EXHAUST SILENCERS

Model: Breva 750

TECHNICAL COMMUNICATION No. 02-2003

TECHNICAL ANNOUNCEMENT NO. 10 - 2003

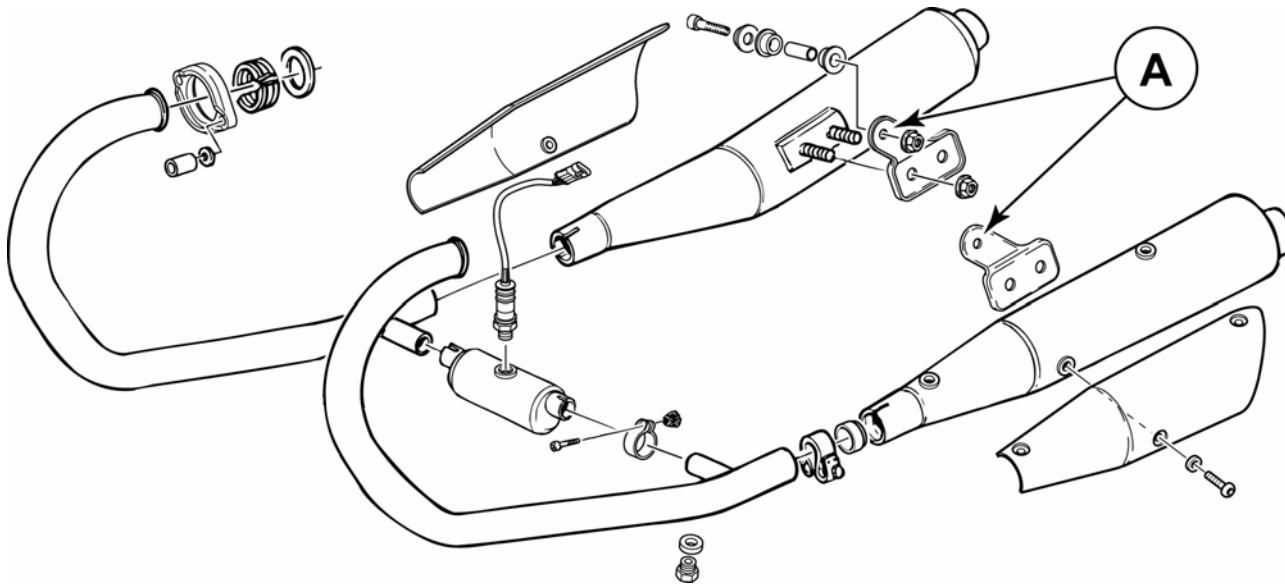
The exhaust silencers come off due to the inadequate length of the exhaust pipes.

For the new bikes, the exhaust pipe length has been changed.

For the bikes already manufactured, the problem can be solved by cutting slots on the silencer brackets (A).

AIR BOX

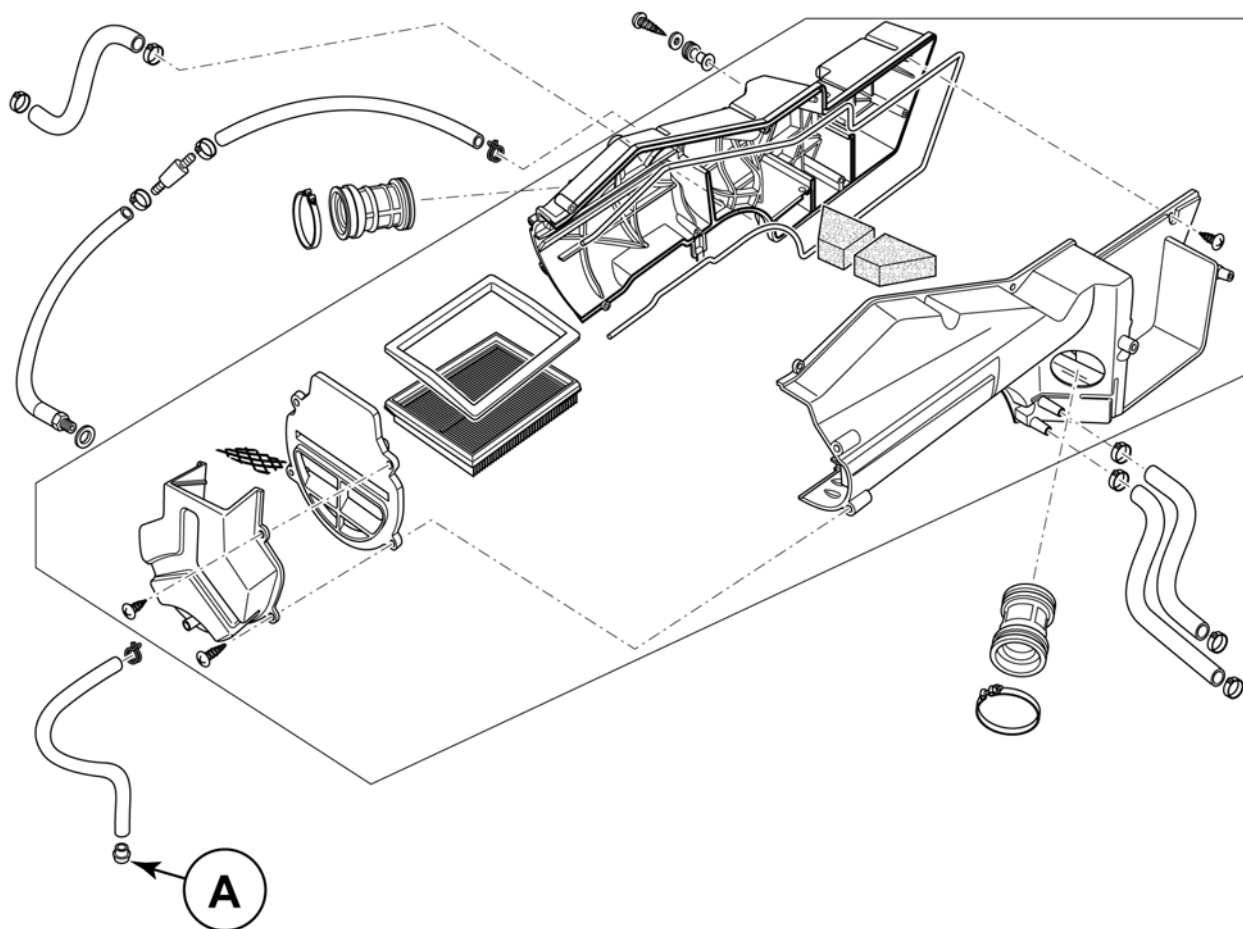
oil entering in the air box stays in the box bottom and goes out of the joints or the plug (A) fitted at the drain pipe end.

before fitting the air box to the vehicle, we check the air box sealing carrying out a leak test with air under pressure.

The plug (A) has been changed with a watertight plug.

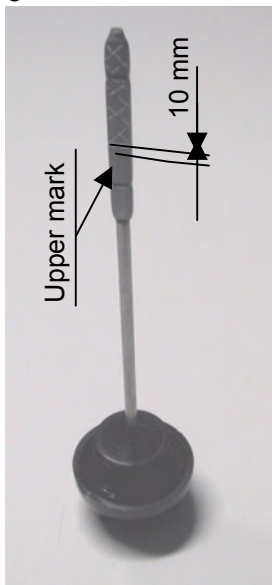
Fault experienced on vehicle: excessive quantity of oil extracted from the oil recover circuit.

Main cause: excessive quantity of engine oil.

An excessive quantity of engine oil can cause an increase in the oil extracted by the crankcase gas recover circuit. In exceptional cases an oil present in the transparent recovery tube, which extends from the filter housing to the rear joint of the right half cradle, type of anomaly can be experienced.

Technical solution: check and restore correct engine oil quantity (1.8 kg).

The checking operation can be easily carried out by using the oil filler cap dipstick. The correct quantity of oil wets the dipstick up to around 10-11 mm under the maximum level reference mark. The highlighted part in the photo shows the section of dipstick which must be wet. The check must be carried out with the engine warmed up, after around 20 minutes that it is running.

THROTTLE POSITION DATA MISSING

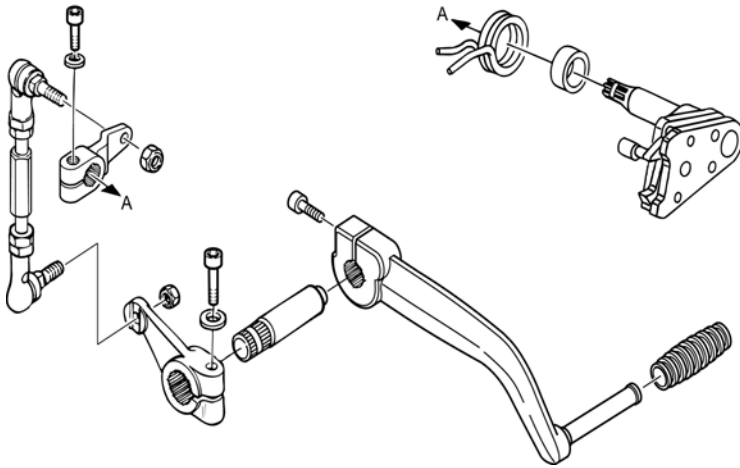
the engine does not work correctly and tends to stop. The parameter "**Correct throttle pos**" read with Axone indicates **2.3 °** (normally, it should read between **2.7°** and **3.5°**).

reset the throttle with Axone.

Adjust the cylinder synchronization and idle speed.

GEARCHANGE PRESELECTOR

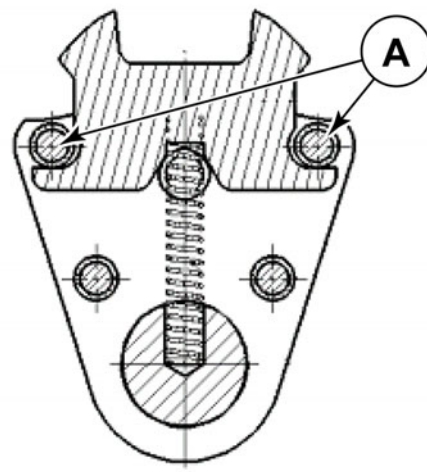
the slide inside the preselector might jam when in contact with the two pins (A).

the diameter of the pins was increased (from 7.0 mm to 7.2 mm), and the concentricity tolerance was decreased.

GEARCHANGE

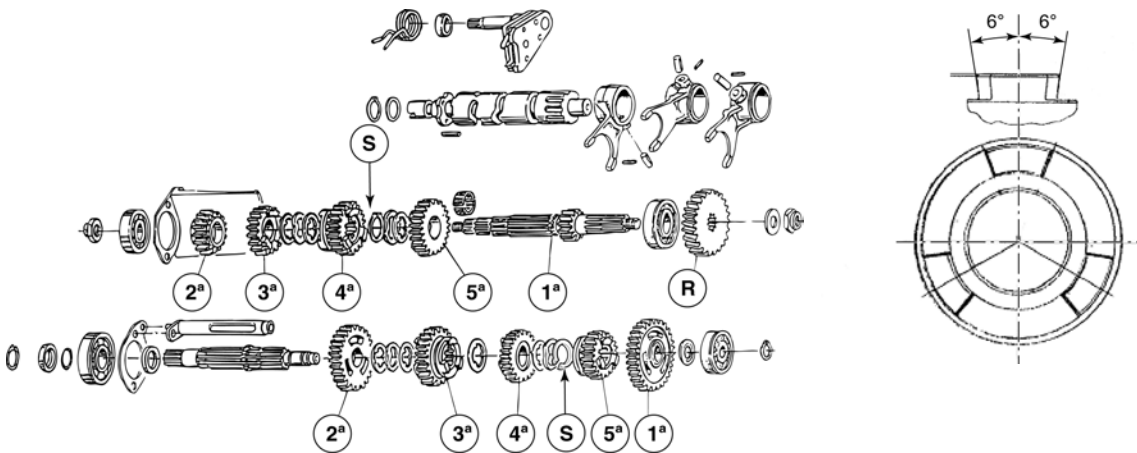
the **3rd** and **4th** gears slip out.
We highlighted two causes:

1. The circlips (**S**) doesn't keep the washer in place.
2. After inspecting the **3rd** and **4th** gears clutch dogs, it was noticed that the angle was not correct (should be **6°**) maybe due to wrong machining or because it was exchanged with one for the Brevia 750 gearchange.

1. it was fitted the circlip for the Brevia gearchange (**inner diameter undersized by 0.5 mm part no. 90271124**).
2. Changing the gears that do not comply with the drawings.

NOTE : the gear for the Nevada 750 gearchange is marked with number 6

AIR BOX

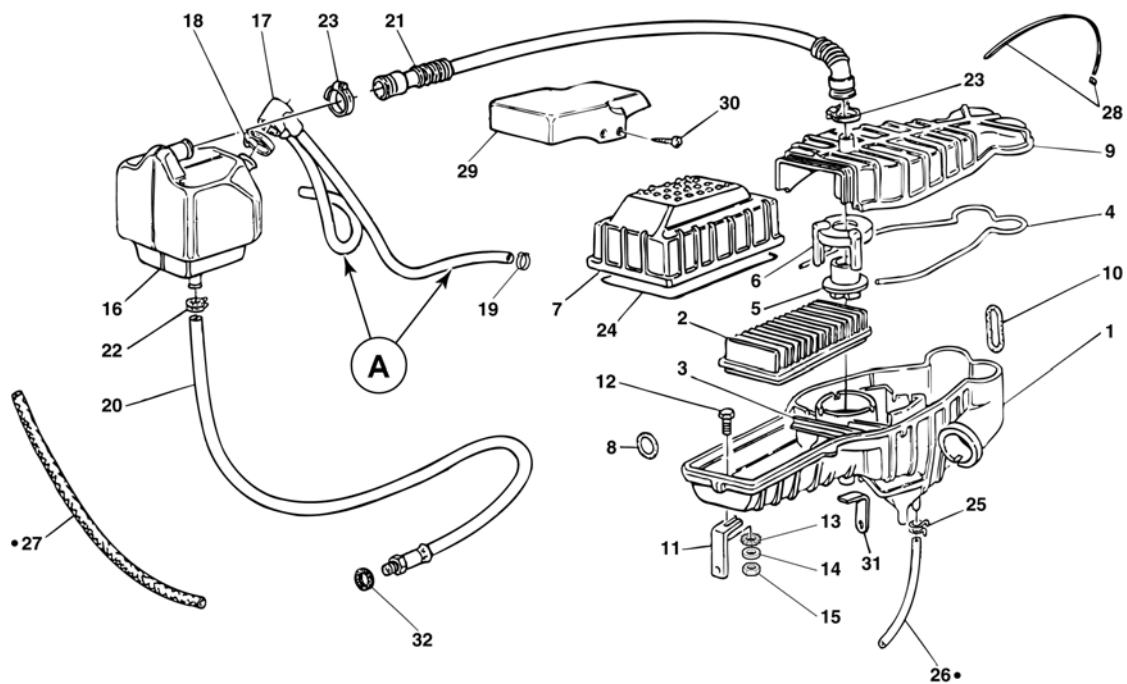
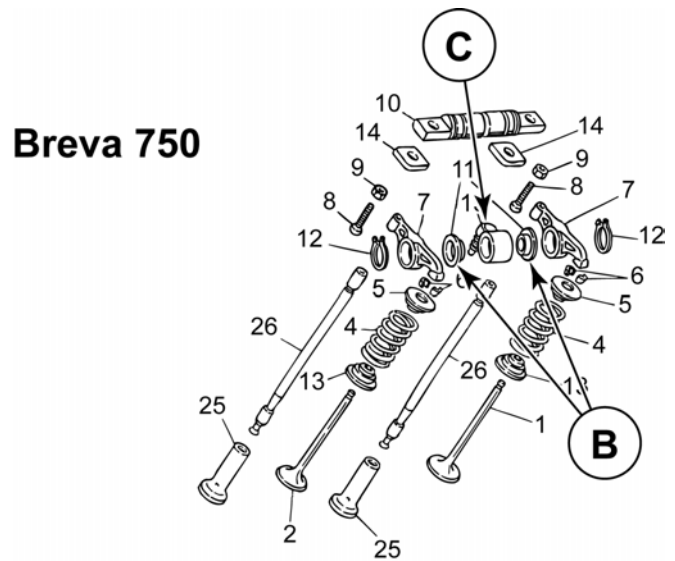
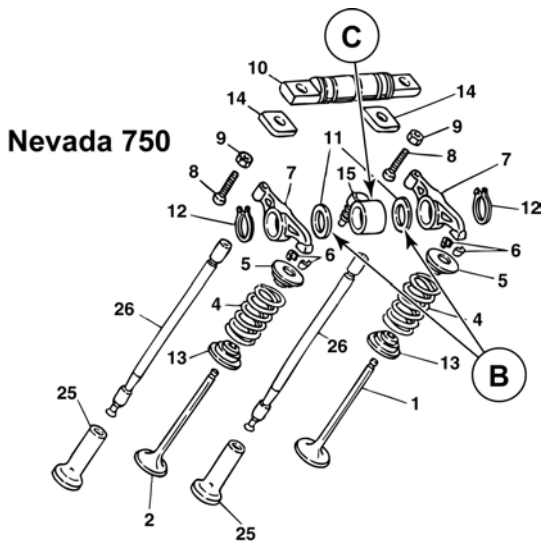
too much oil in the air box

The presence of oil in the decanter box and -following oil vapours circuit- in the air box has two main causes:

- too high oil level
- high pressure of the gases inside the crankcase

- Check that the two hoses (A) taking the oil vapours from the head covers to the decanter are not squashed due to their flexibility; if so, change them with more rigid hoses.

- Change the hose (C) and the shims (B) with the ones for the Brevia 750 model (for vehicles manufactured before 2003).

- Should the problem persist, change the piston rings.
- Should it be necessary to change the pistons, it is recommended to change them with the ones for Brevia model.

TECHNICAL COMMUNICATION No. 02-2003**17 April 2003**

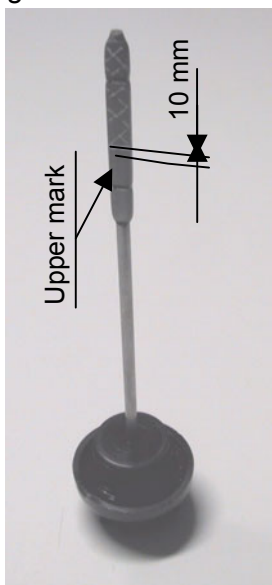
Fault experienced on vehicle: excessive quantity of oil extracted from the oil recover circuit.

Main cause: excessive quantity of engine oil.

An excessive quantity of engine oil can cause an increase in the oil extracted by the crankcase gas recover circuit. In exceptional cases an oil present in the transparent recovery tube, which extends from the filter housing to the rear joint of the right half cradle, type of anomaly can be experienced.

Technical solution: check and restore correct engine oil quantity (1.8 kg).

The checking operation can be easily carried out by using the oil filler cap dipstick. The correct quantity of oil wets the dipstick up to around 10-11 mm under the maximum level reference mark. The highlighted part in the photo shows the section of dipstick which must be wet. The check must be carried out with the engine warmed up, after around 20 minutes that it is running.

BATTERY

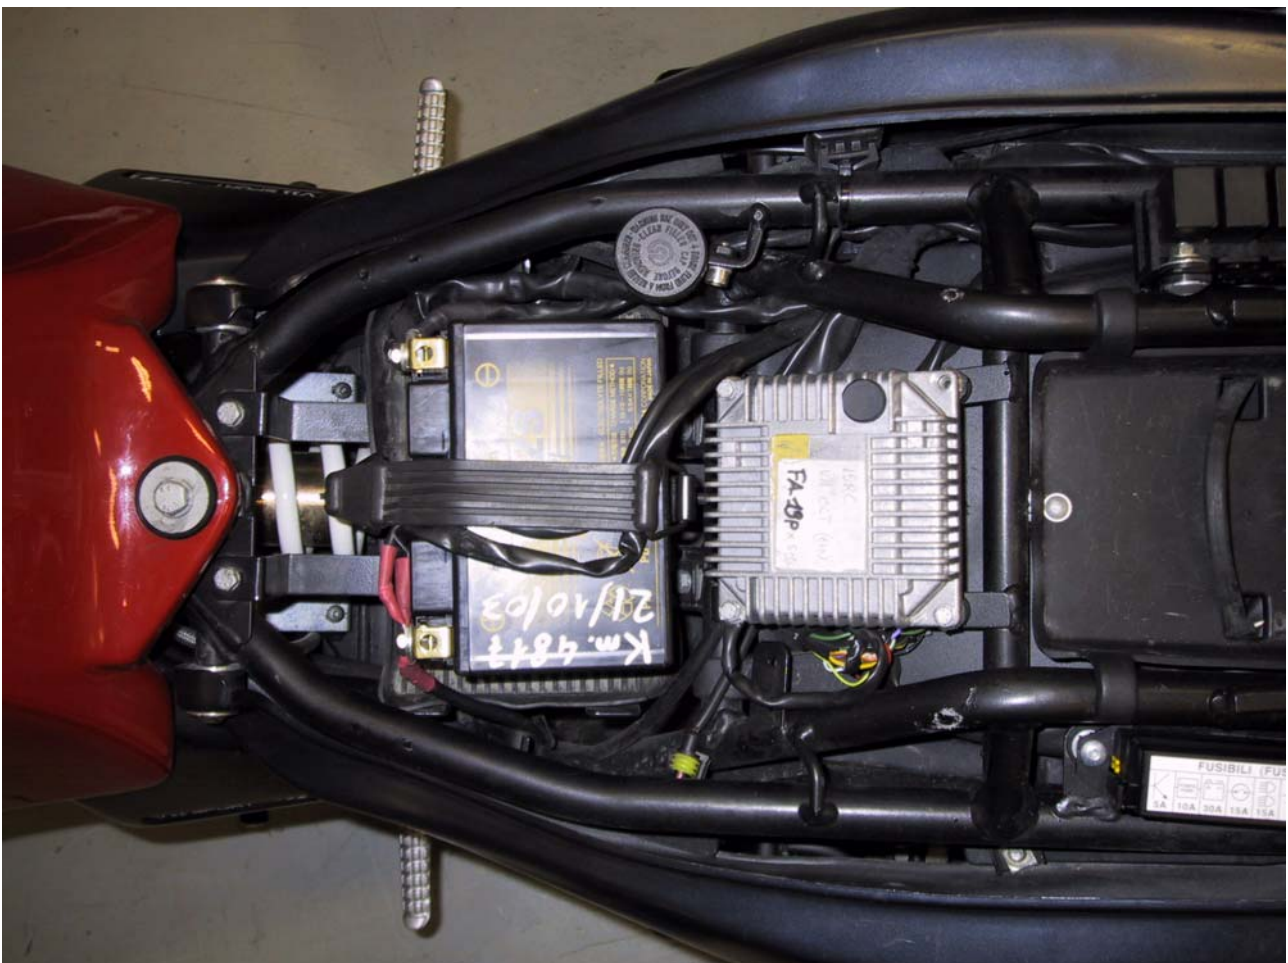
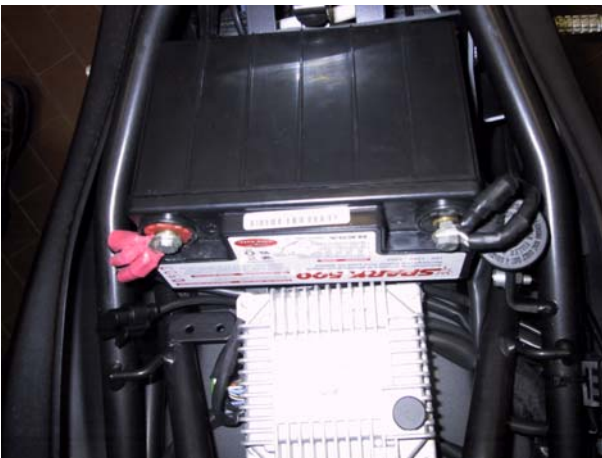
short life-span of the presently fitted **ESA SPARK 500E** battery.

the **YUASA YTZ12S** battery will be fitted (comes from Yuasa already filled with fluid).

In production is fitted a new wiring while on bikes with present wiring it is possible to fit the battery and re-route the cables.
